Discovery 2010 Announcement of Opportunity Q&A Updated March 31, 2010

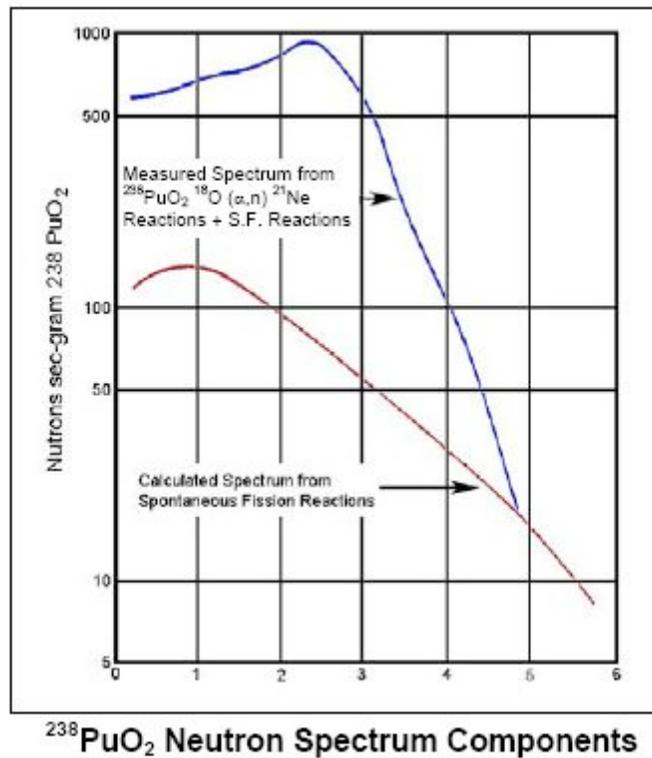
AR-8 *The first paragraph of Section 2.2 of the ASRG Information Summary in the Program Library document states that “Proposers should use...a system mass of 25 kg for planning purposes...” Using the definitions of Requirement B-34 on page B-16, should the 25 kg identified for the ASRG mass be used for the “current best estimate” or the “max expected?”*

The updated current best estimate (CBE) with design margin is 28.0 kg. The mass has grown due to additional levied requirements by NASA. The Program is holding a 5% reserve on the 28 kg, thus 29.5 kg should be used for planning purposes. This reserve will be released as the ASRG design gates PDR and CDR are achieved.

Margin is defined here to accommodate design known unknowns and reserve is for accommodating unknown unknowns. The masses for the ASRG to spacecraft (S/C) mounting plate and controller cable are not included since these items are mission or S/C specific.
